**Development Permit Panel
Wednesday, July 10, 2019**

1. DEVELOPMENT PERMIT 11-593871
(REDMS No. 6204334 v. 2)

PROPERTY LOCATION: 6302 No. 3 Road and 6411 Buswell Street

RICHMOND-BRIGHOUSE BUS MALL

ACOUSTIC SCREEN

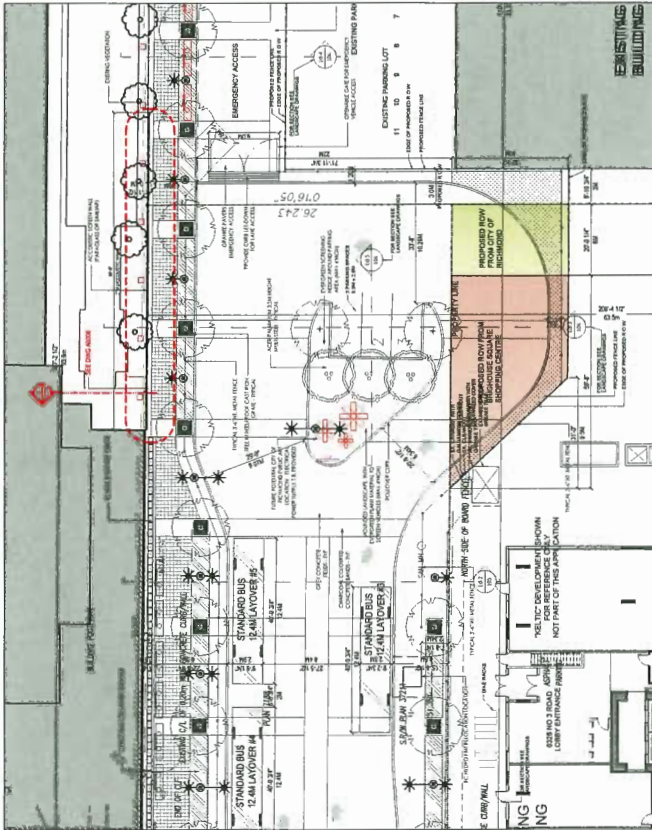
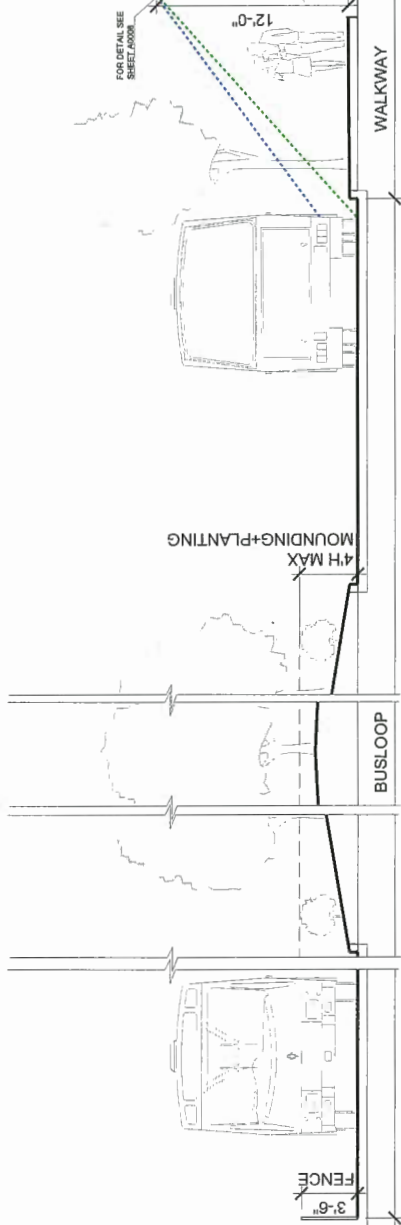
1) According to Key Plan on Document A0005, the proposed acoustic wall only covers the first three townhouse units from the left. Is this enough to protect the entire row of townhouses along the proposed bus mall?

3) In the earlier letter from the acoustic engineer that you have kindly sent me (dated December 9, 2015), the acoustic wall was proposed to be 9 feet tall. The currently proposed wall is 12 feet tall.

3a) What are the differences?

3b) Is 12 feet tall wall enough to provide protection on the top floor patio (exterior of the 4th floor, as opposed to the interior portion)?

1. Townhouses at the east end will have a partial view to buses past the end of the barrier. Our evaluation indicates bus noise should be less than 60 dB at these townhouses, based on the reduced angle of view and increased distance from the source.
2. CMHC recommends 55 dB for outdoor recreation areas, which "permits conversation at close range or in a slightly raised voice" and is not a design requirement for patios, balconies, etc. For reference, traffic noise normally exceeds 55 dB on balconies in proximity to arterial roads.

3a.) The barrier will provide a nominal 5-10 decibel reduction at locations where the line of sight to buses is through the barrier. A 12ft high barrier would provide slightly more shielding than a 9ft barrier.

3b.) See item 2. above.

Section through bus loop - A
scale 1/4" = 1'-0"

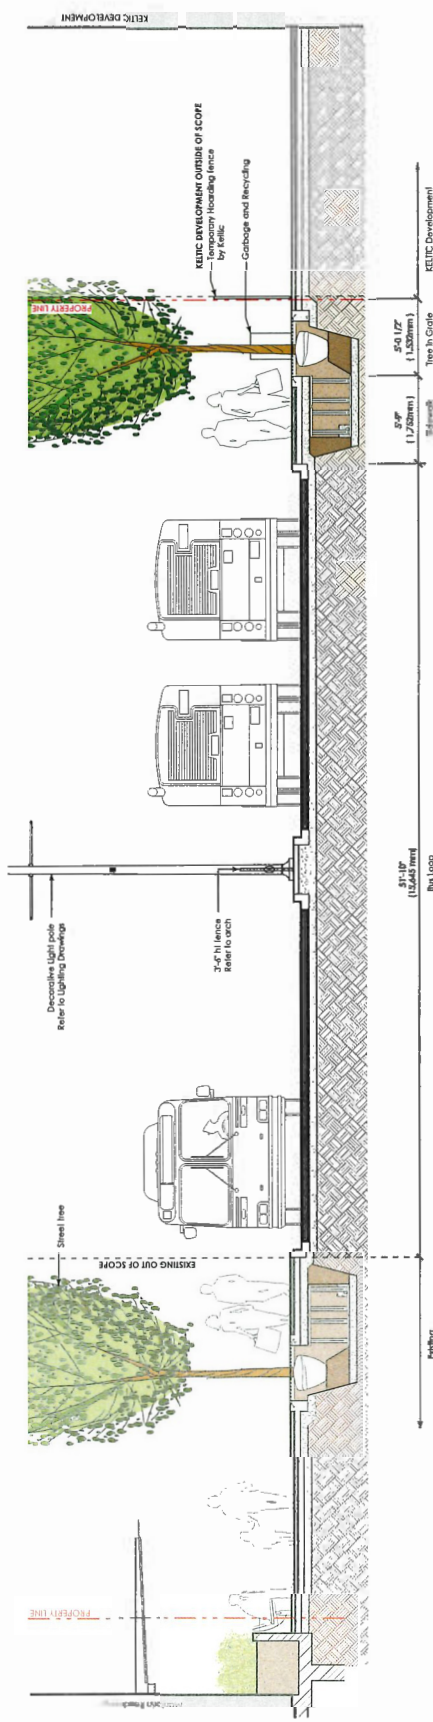
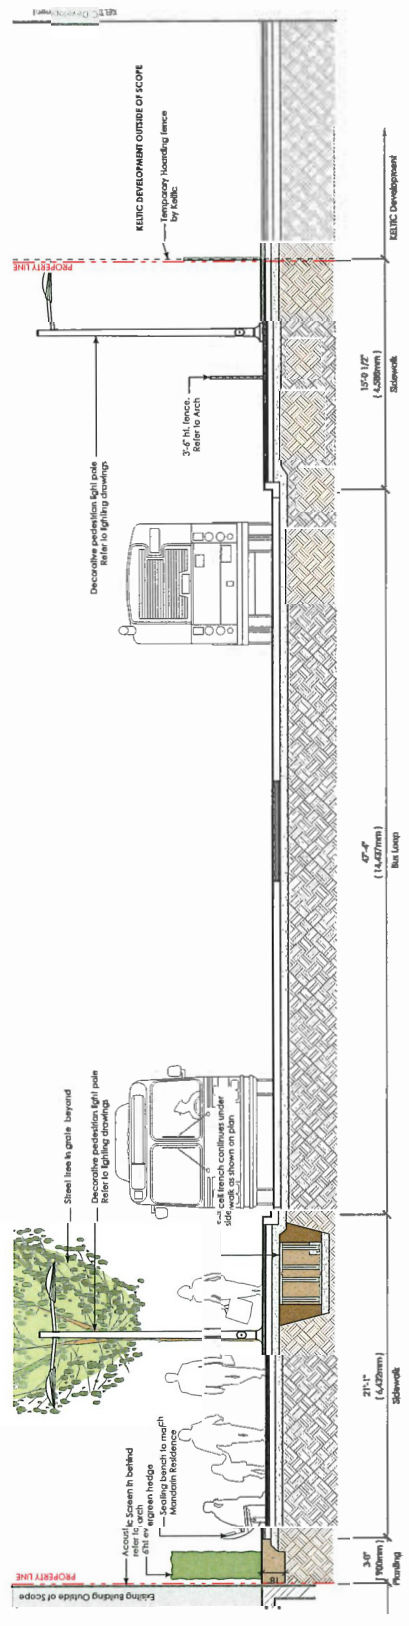
I also attach details of the acoustic wall itself. You will notice on the cross-section drawing, lines which emanate from the bottom of the wheels of the bus. The point of contact where the wheels meet the pavement is typically the primary source of noise. The height of the acoustic fence is such that it shields the lower 4 floors of Emporio from this direct noise.
